From: Scala, Mary Joy
Sent: Wednesday, July 17, 2013 9:10 AM
To: Mark Van Sickle (MVanSickle@littleonline.com)
Cc: stephen.hruska@lincolnharris.com; Shane Brandwood (SBrandwood@littleonline.com)
Subject: BAR Action 1619 University Avenue July 16, 2013

BAR 13-05-01
1619 University Avenue
Tax Map 9 Parcel 102
Stephen Hruska, Applicant/ Sovran Bank, Owner
Site demolition and ADA Renovation to front sidewalk area

Bank of America University ADA Renovation

C2.00

C1.01

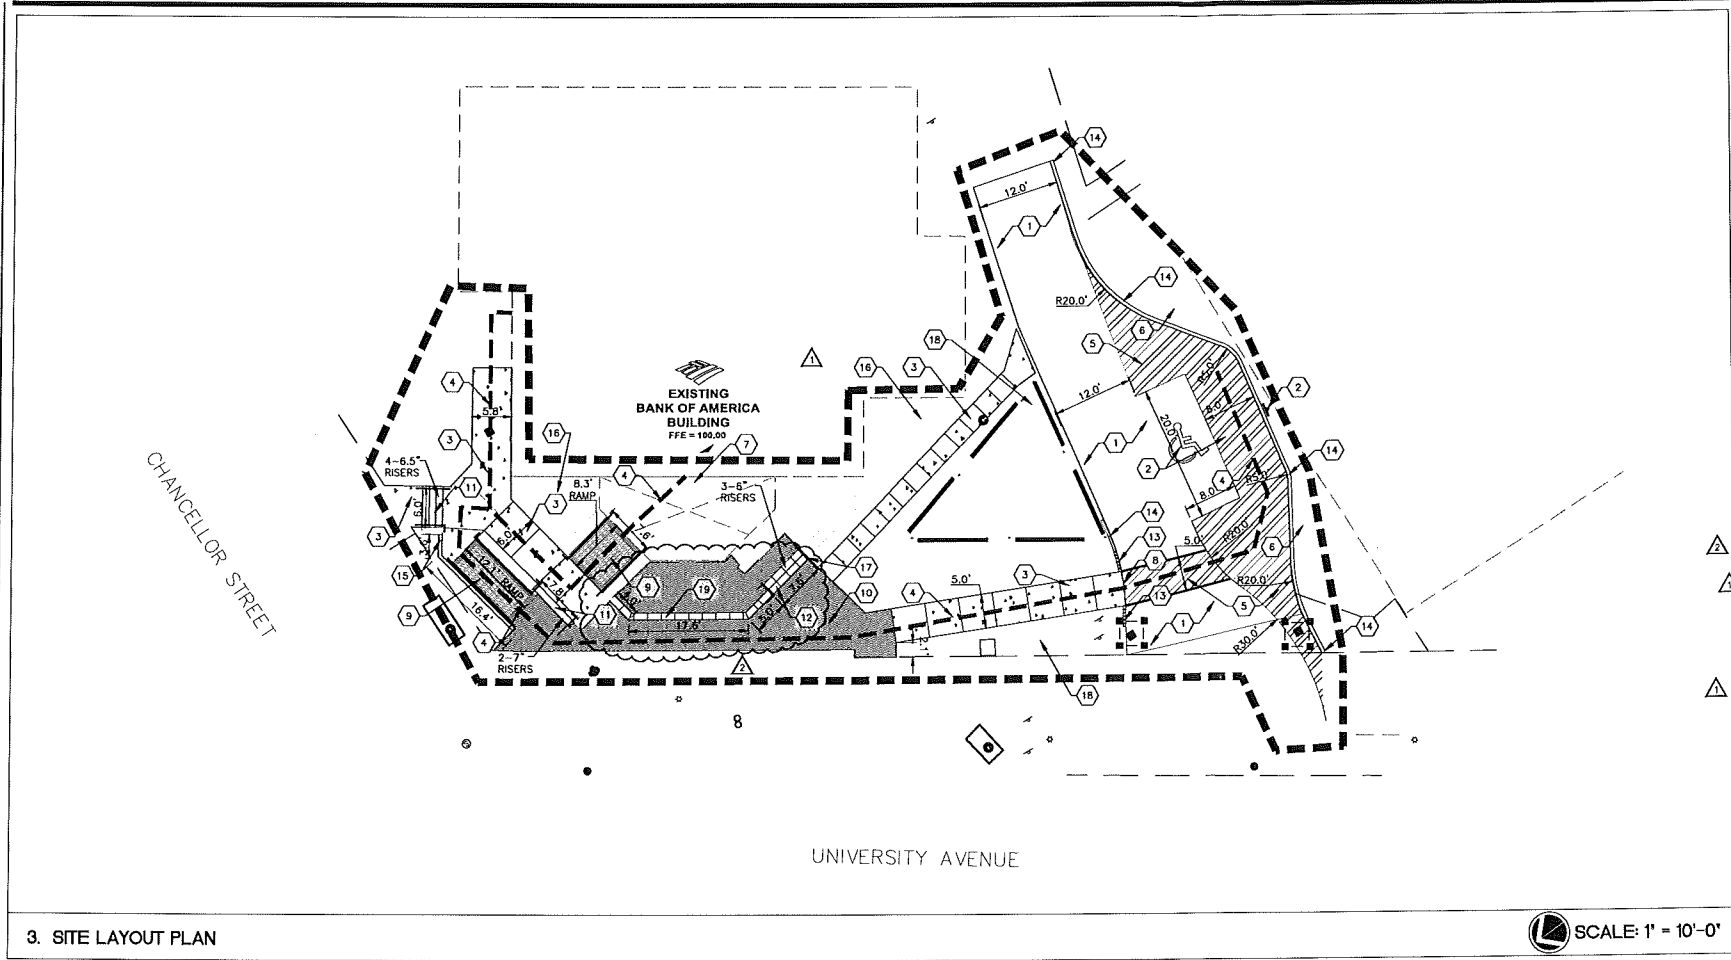
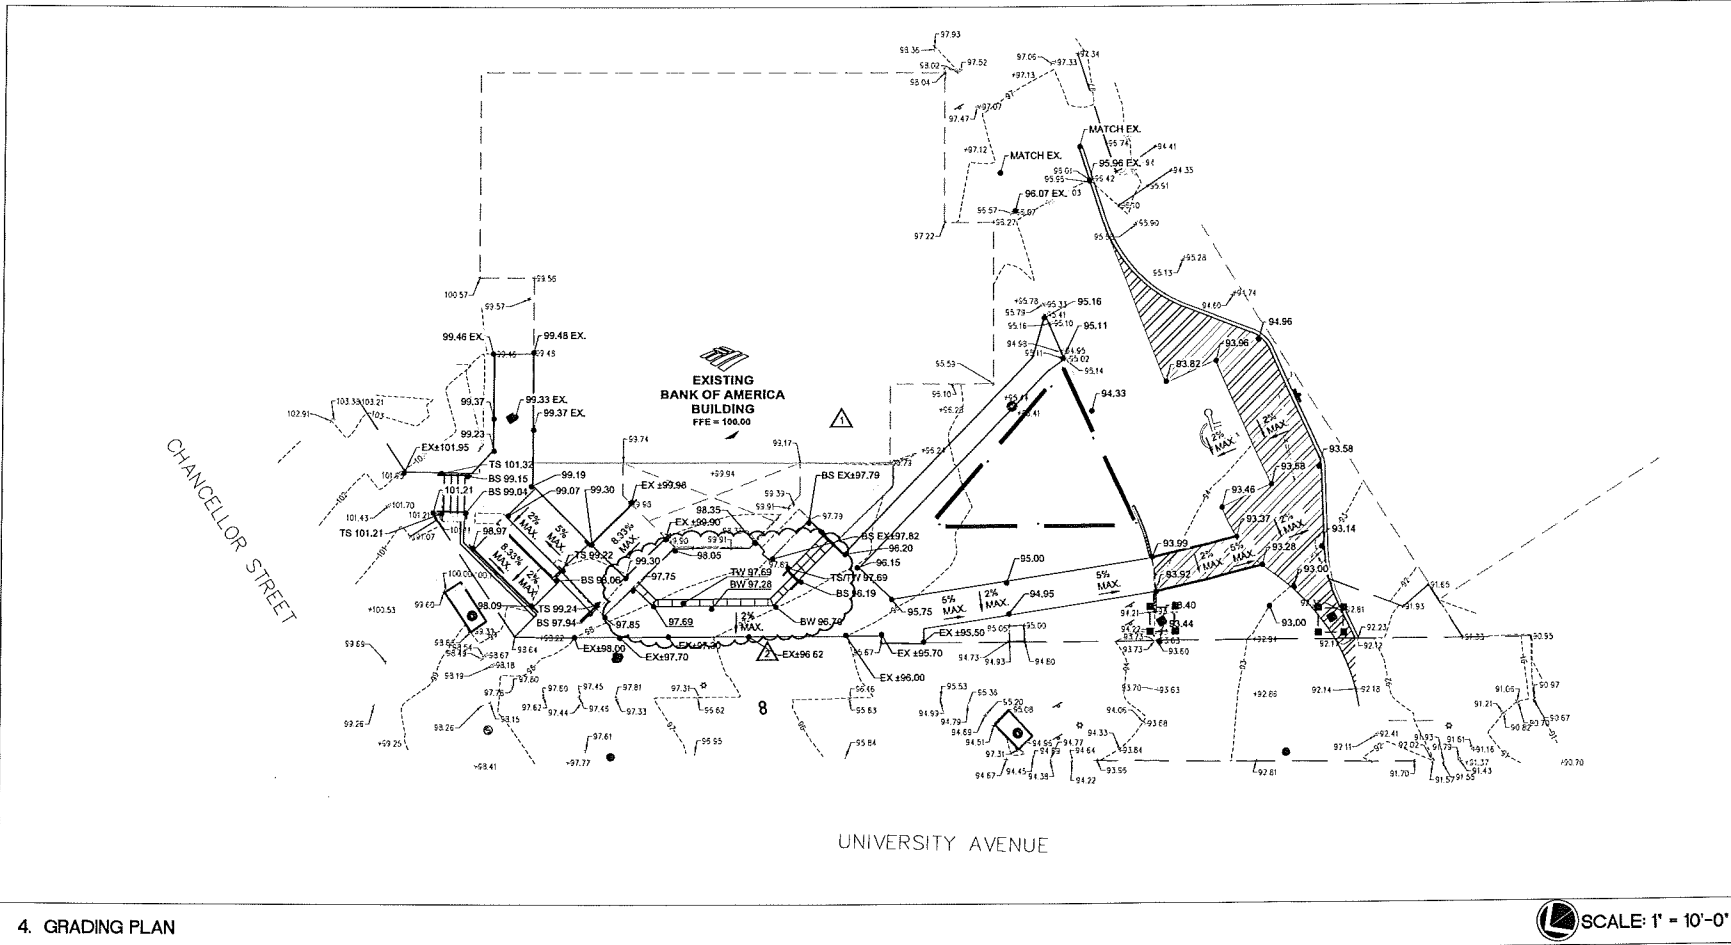
Approved (4-2 with Adams and Osteen opposed) with conditions that the handrail design will match existing; eliminate two stairs in the center front; carry the bluestone cap detail across so it breaks the upper level from lower level; carry City sidewalk brick color to wall*; clean up geometry east side so there is a memory of an arc. Resubmit digitally to staff to be circulated to BAR for approval; *include two photoshop versions of brick color [dark City sidewalk brick and red brick to match existing] so final decision can be made.

Approved (4-2 with Adams and Osteen opposed) with conditions that the handrail design will match existing; eliminate two stairs in the center front; carry the bluestone cap detail across so it breaks the upper level from lower level; carry City sidewalk brick color to wall*; clean up geometry east side so there is a memory of an arc. Resubmit digitally to staff to be circulated to BAR for approval; *include two photoshop versions of brick color [dark City sidewalk brick and red brick to match existing] so final decision can be made.

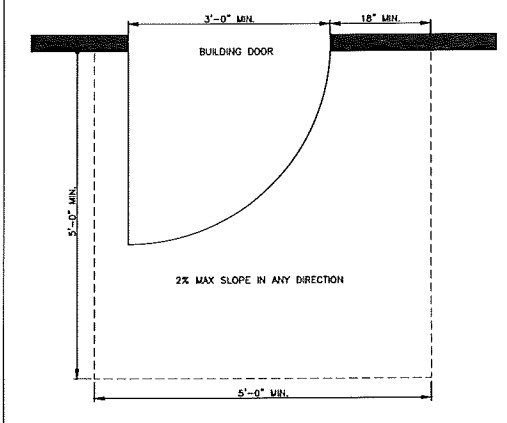
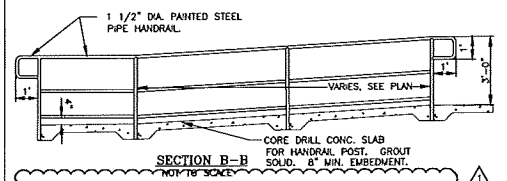
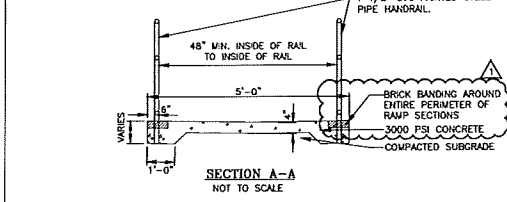
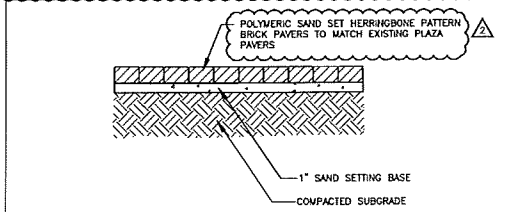
1. Your handrail notes 5 and 7 on Sheet C2.00 should make it clear that the existing rails to be matched are picket. Right now the details show a different type of handrail.
2. You need to specify a brand and color for your plaza bricks. Will they be Old Virginia bricks as the BAR recommended?
3. You are supposed to keep the memory of an arc on the east side of the plaza. I don't see that at all.

- NOTES:**
1. ALL HANDRAILS SHALL BE 1 1/2\"/>
 - 2. HANDRAILS TO MATCH EXISTING RAIL PROFILE.
